Addendum No. 1
May 30, 2023

Project: Dell Rapids City and Community Hall
317 E 4th ST Dell Rapids, South Dakota
Architecture Incorporated Project #2999

Architect: Architecture Incorporated

MAIN FLOOR PLAN - DEMO - ELECTRICAL
SCALE 0 2 4 6 8

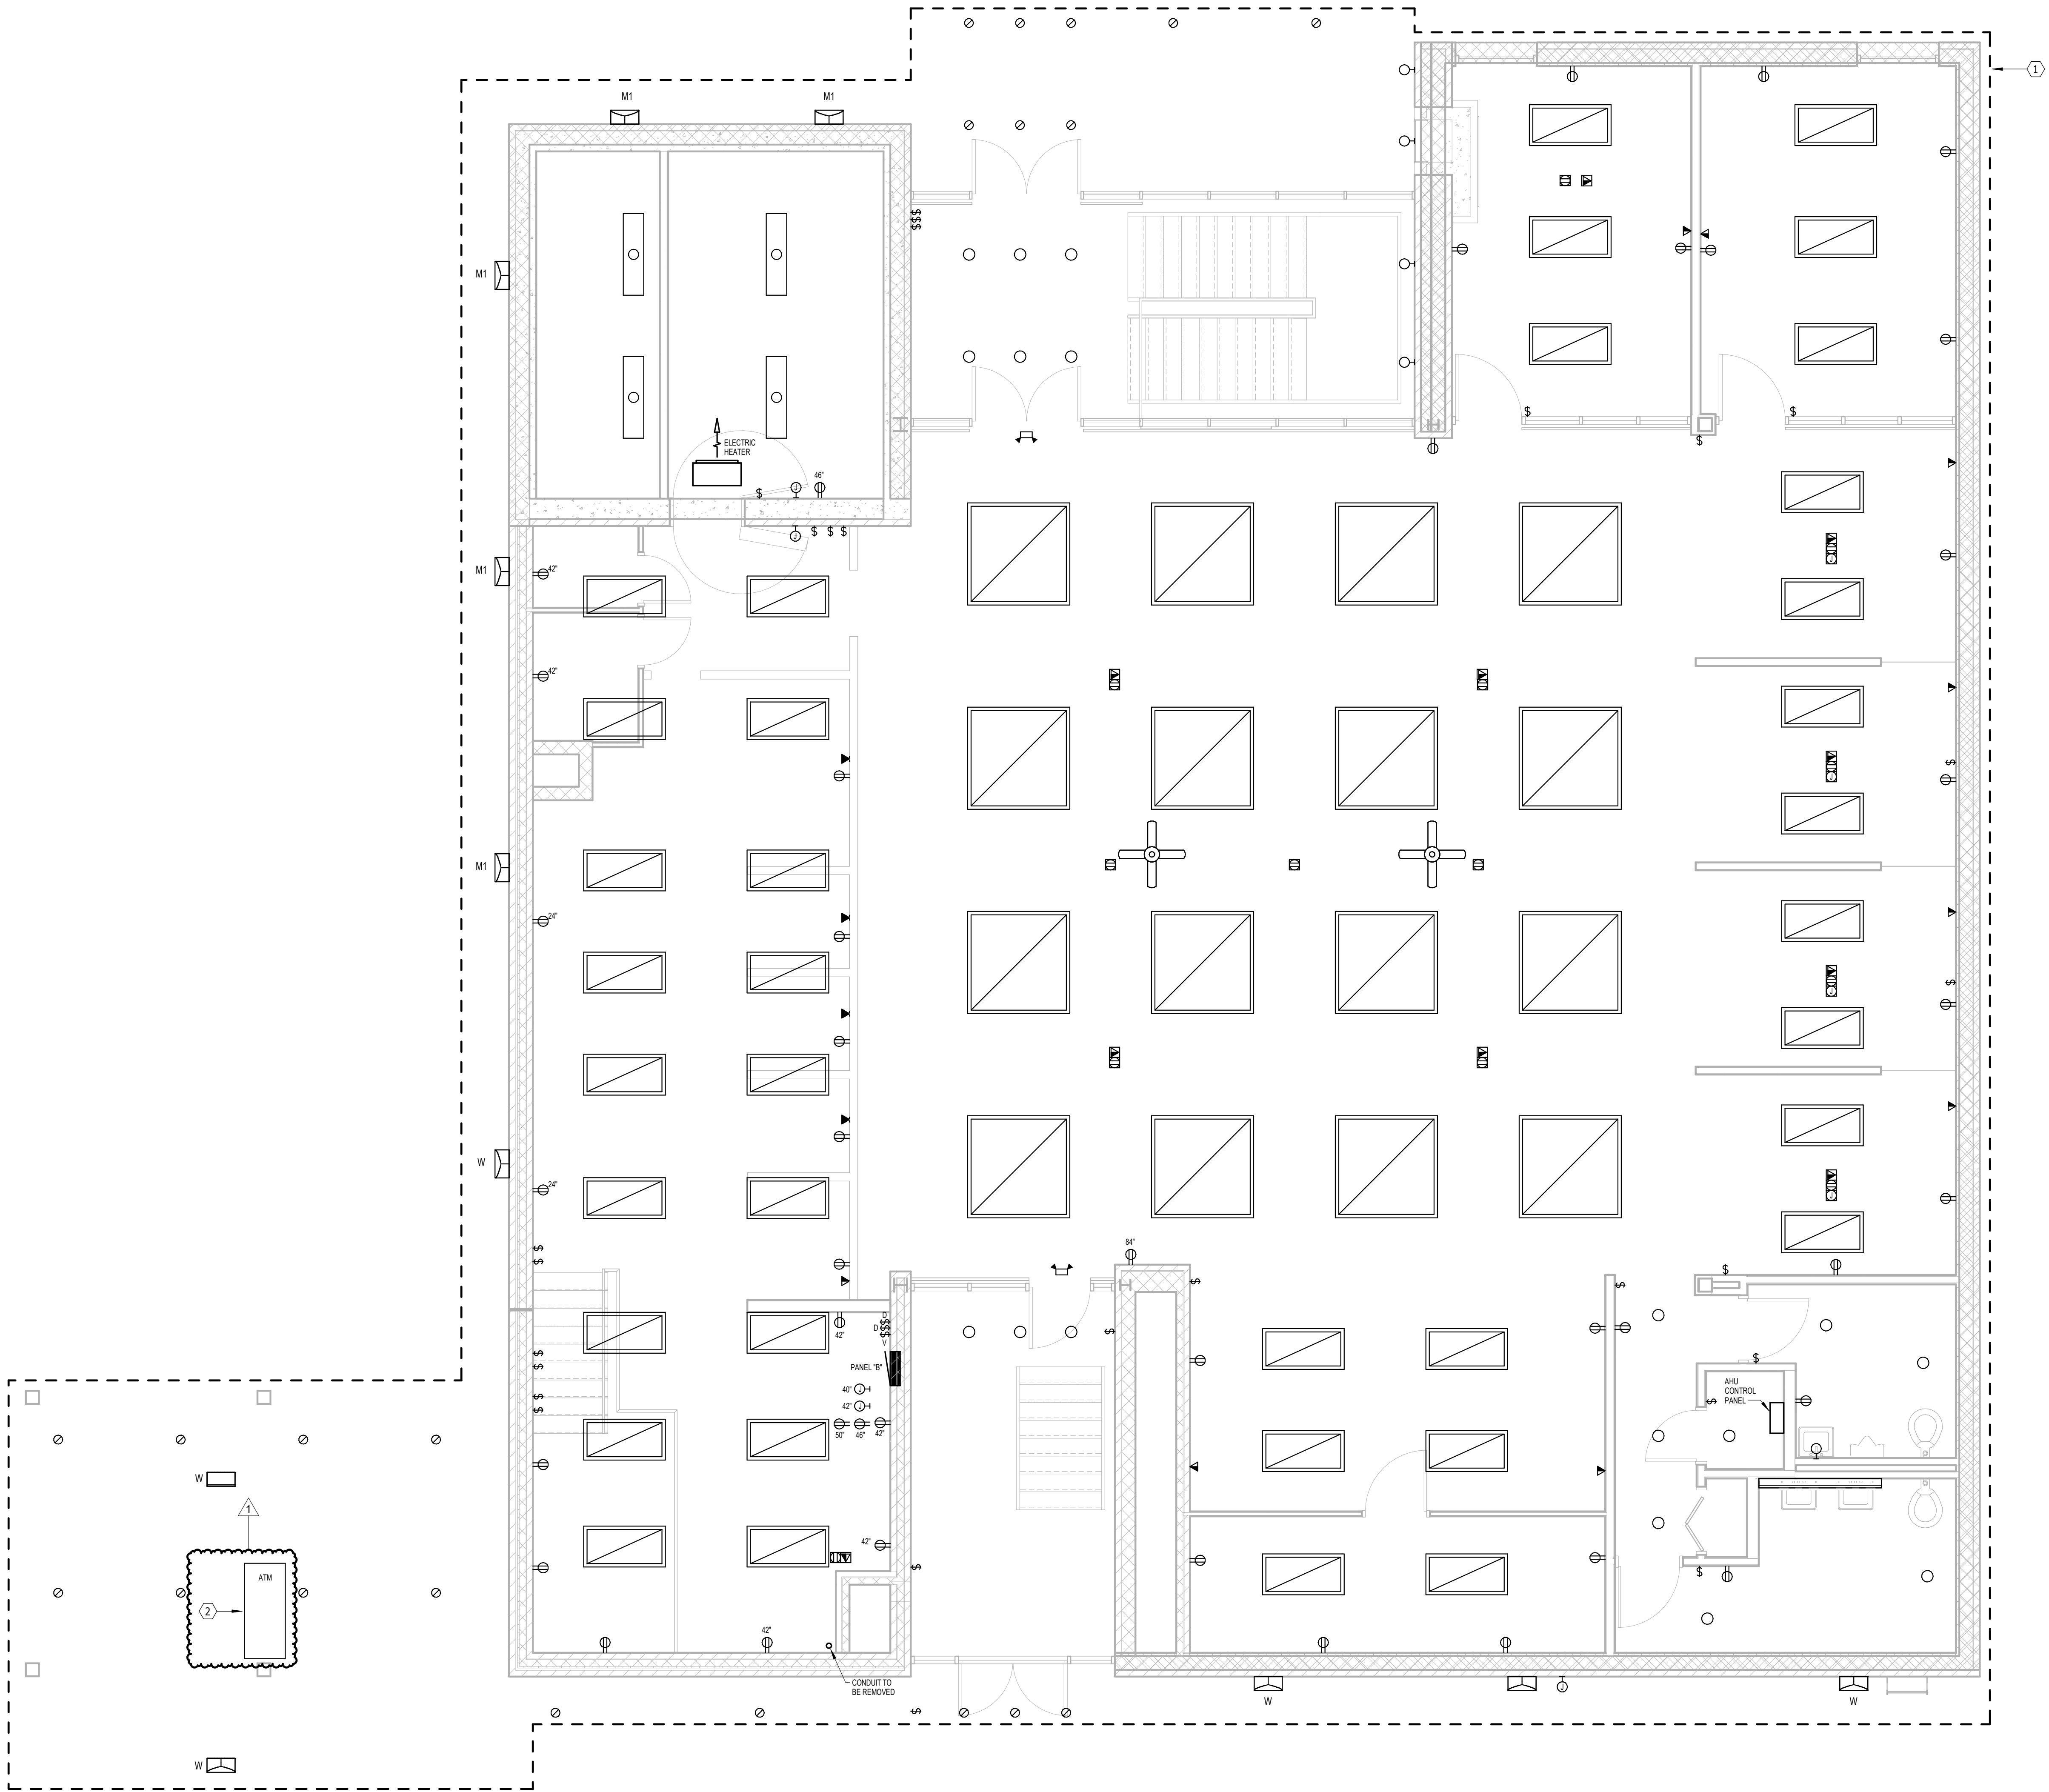
1. Add keynote 2 which is to read “ATM TO REMAIN OPERATIONAL DURING CONSTRUCTION. ELECTRICAL CIRCUITS AND COMMUNICATIONS TO REMAIN IN PLACE UNTIL NEW ELECTRICAL SERVICE IS INSTALLED FOR ATM. ALL OUTAGES TO BE COORDINATED WITH OWNER.”

BASEMENT FLOOR PLAN - POWER & SIGNAL

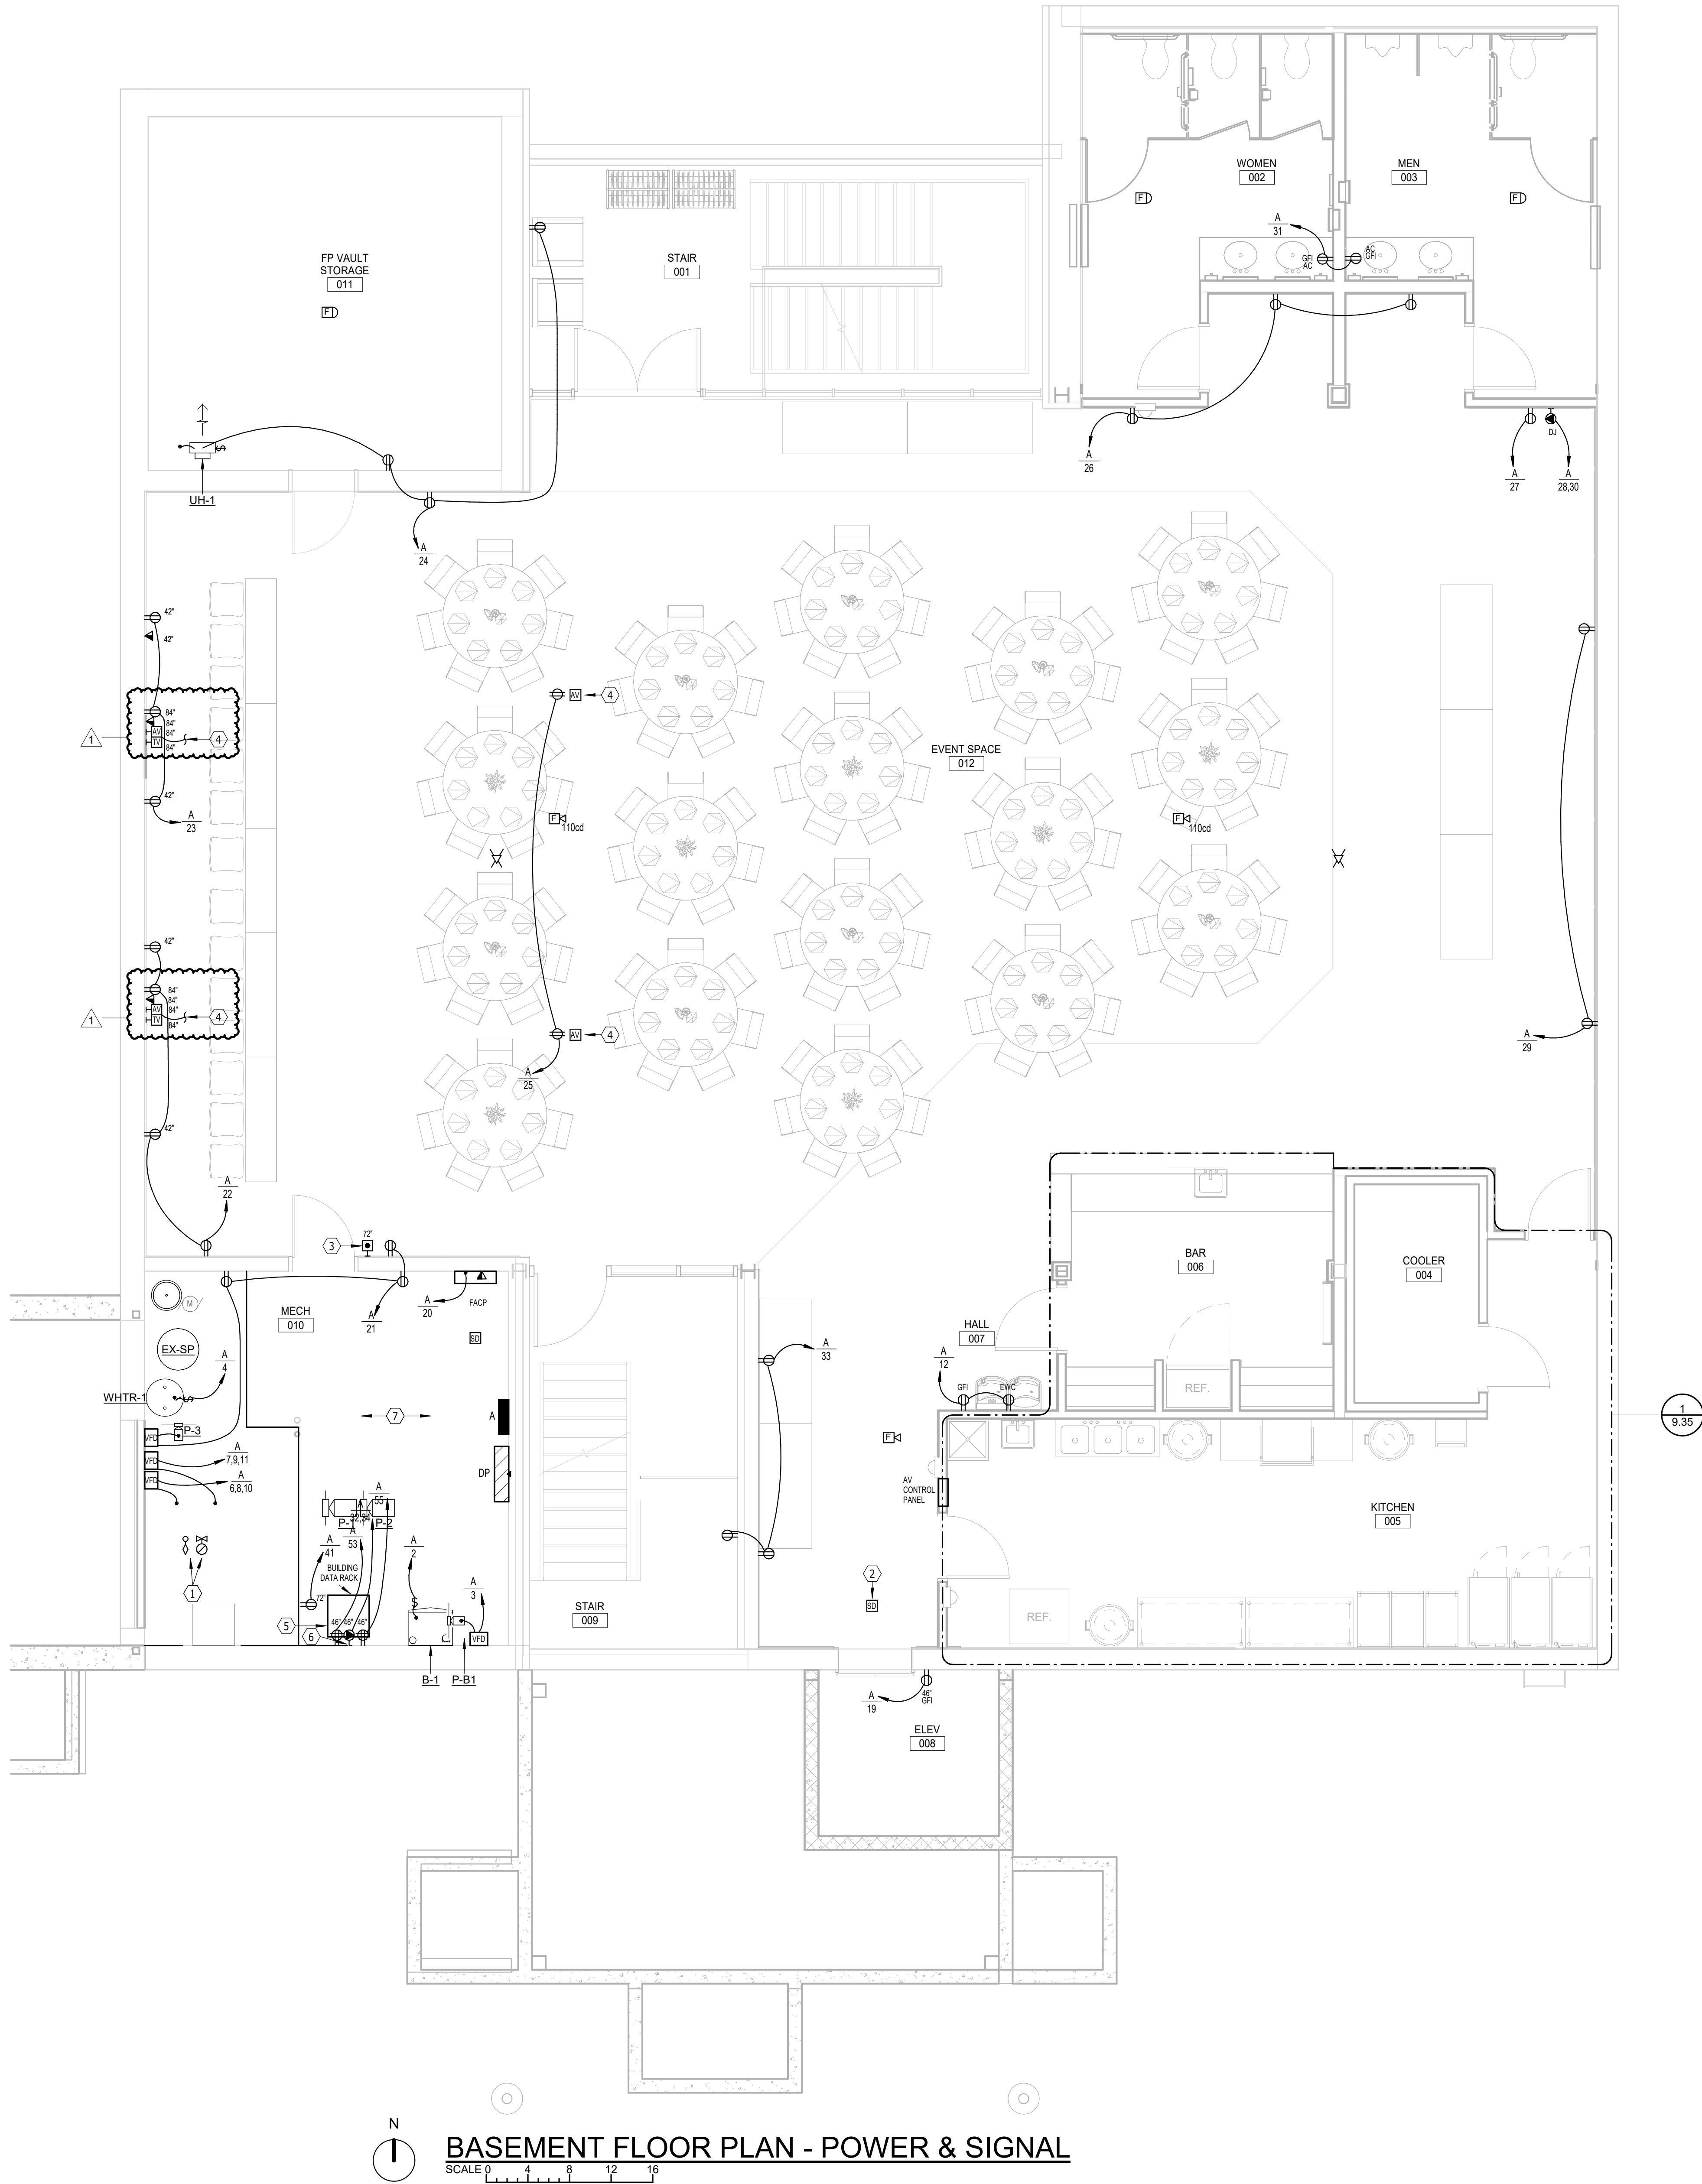
1. Add electrical receptacles and data drops at each projector screen location as shown on revised drawings.

KITCHEN/BAR PLAN - ELECTRICAL
SCALE 0 1 2 3 4

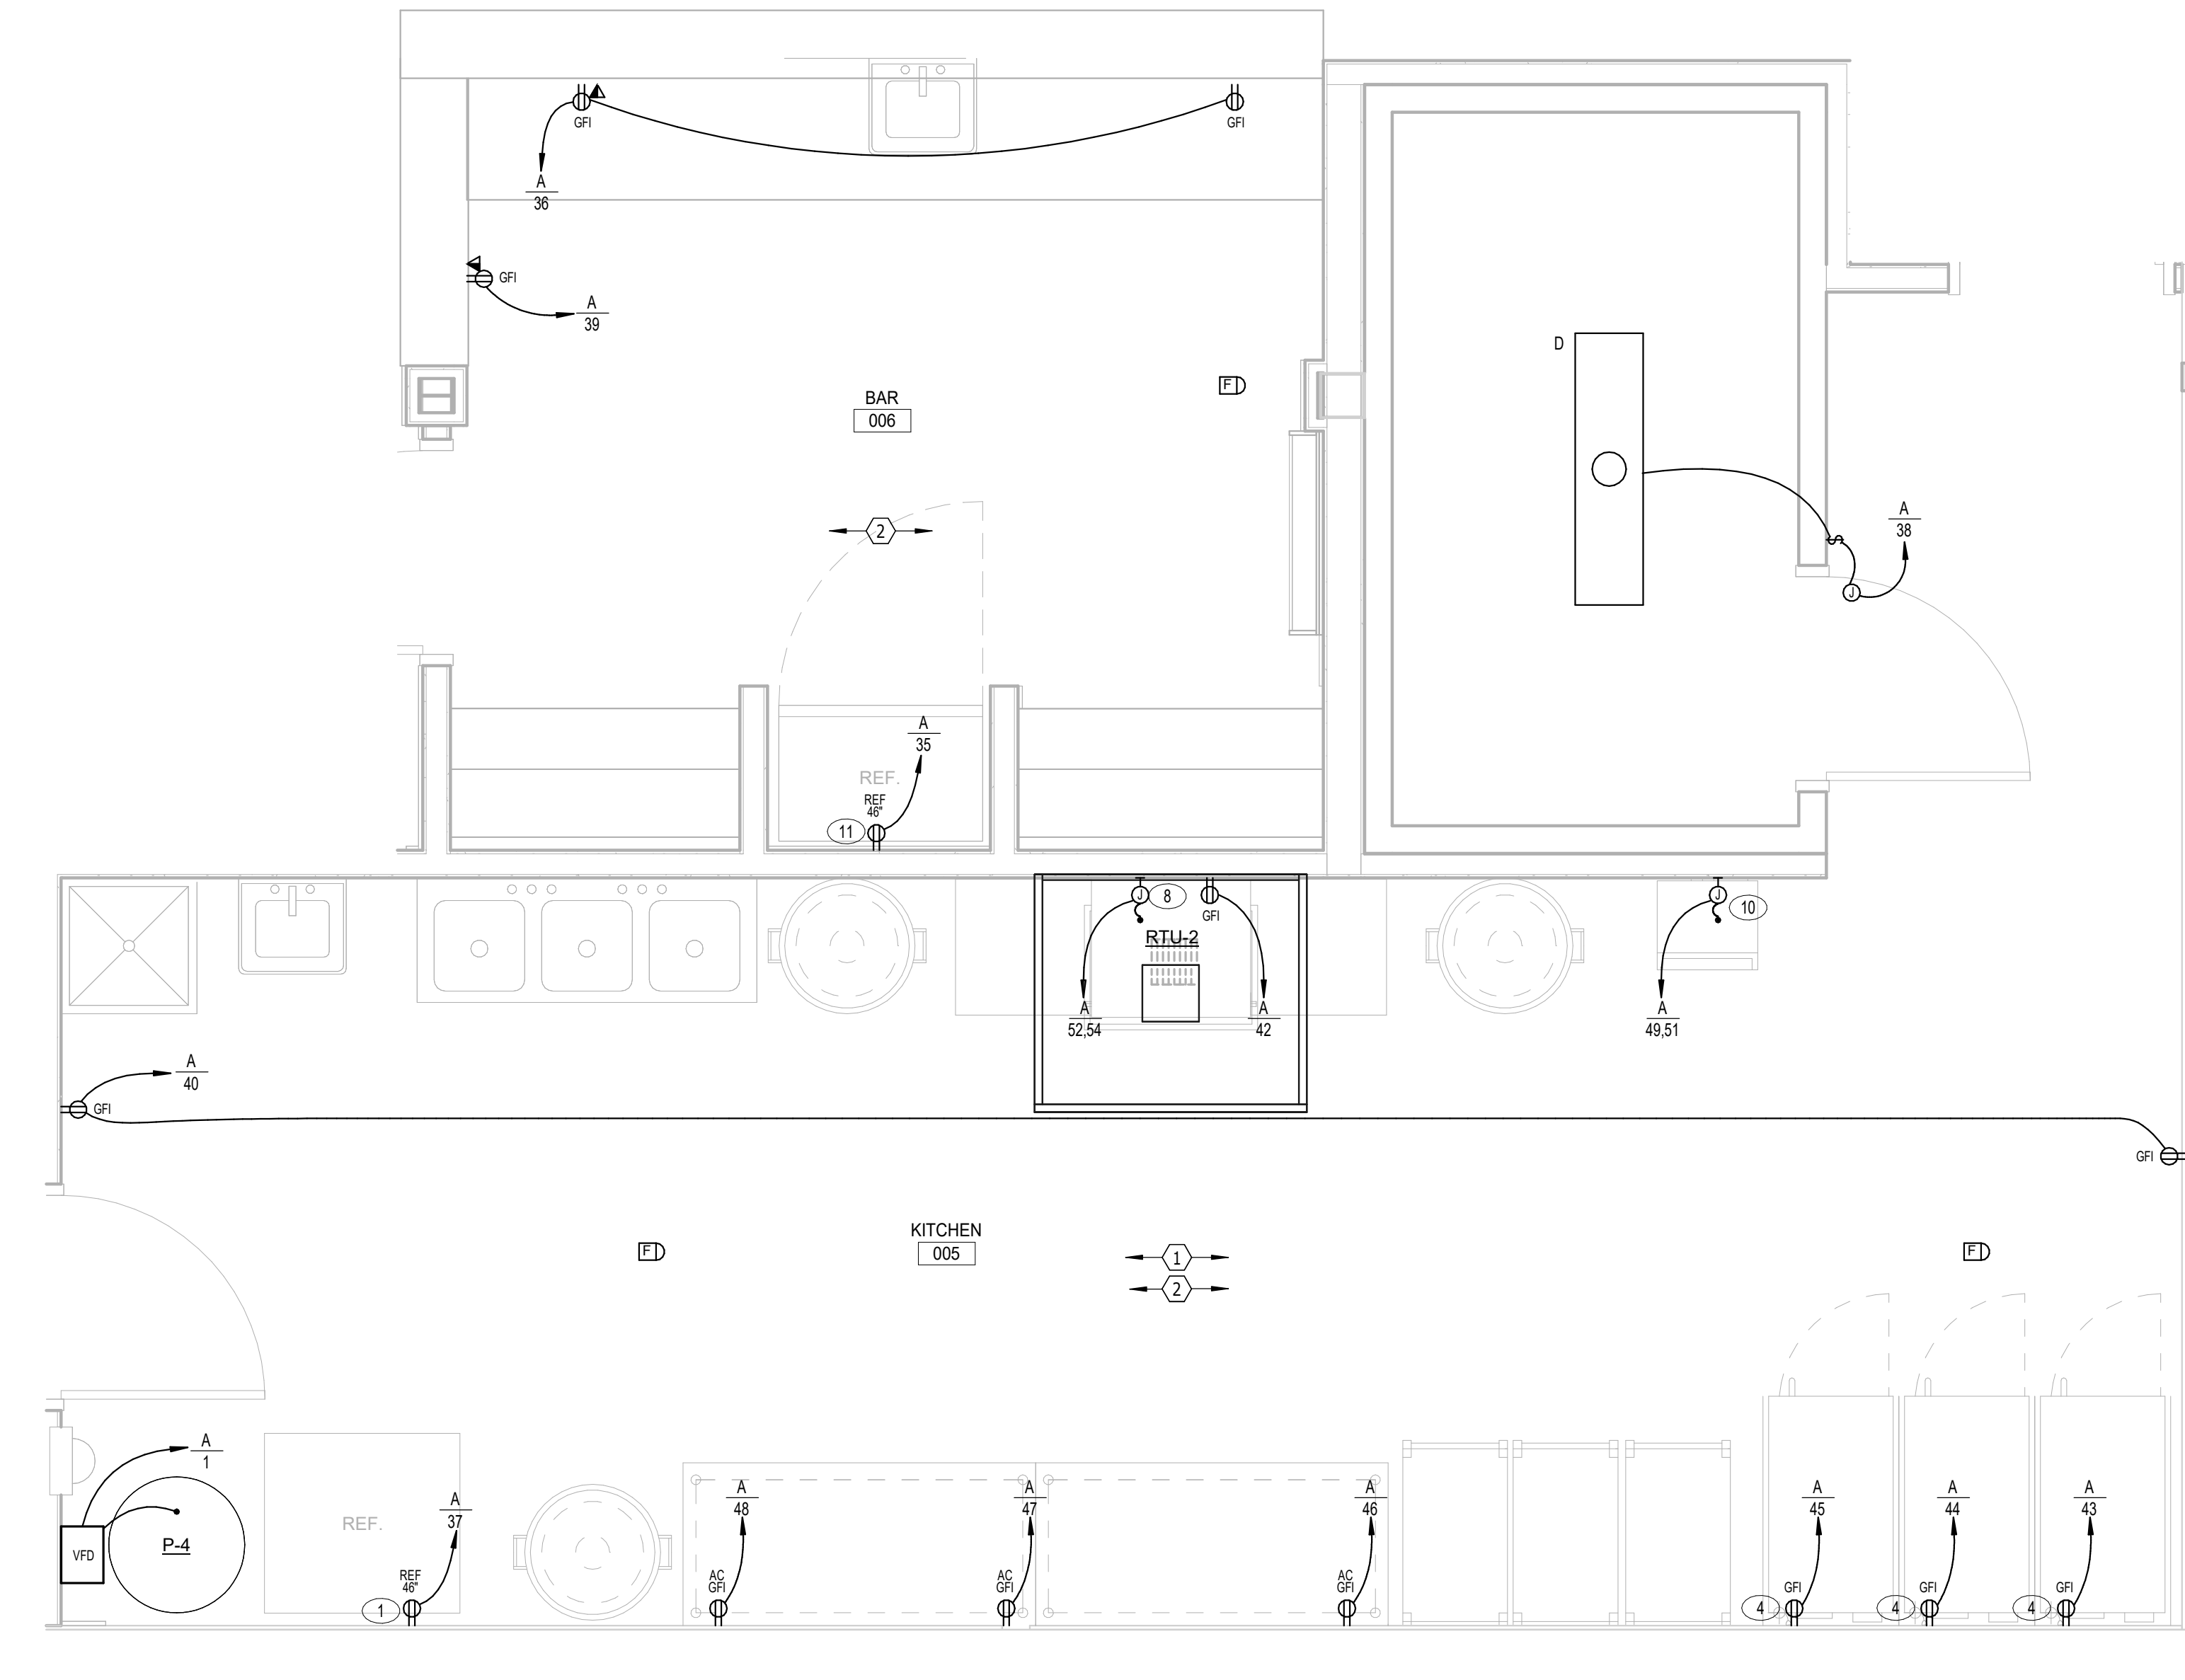
1. Kitchen Equipment Schedule to be updated as shown on the revised drawing.
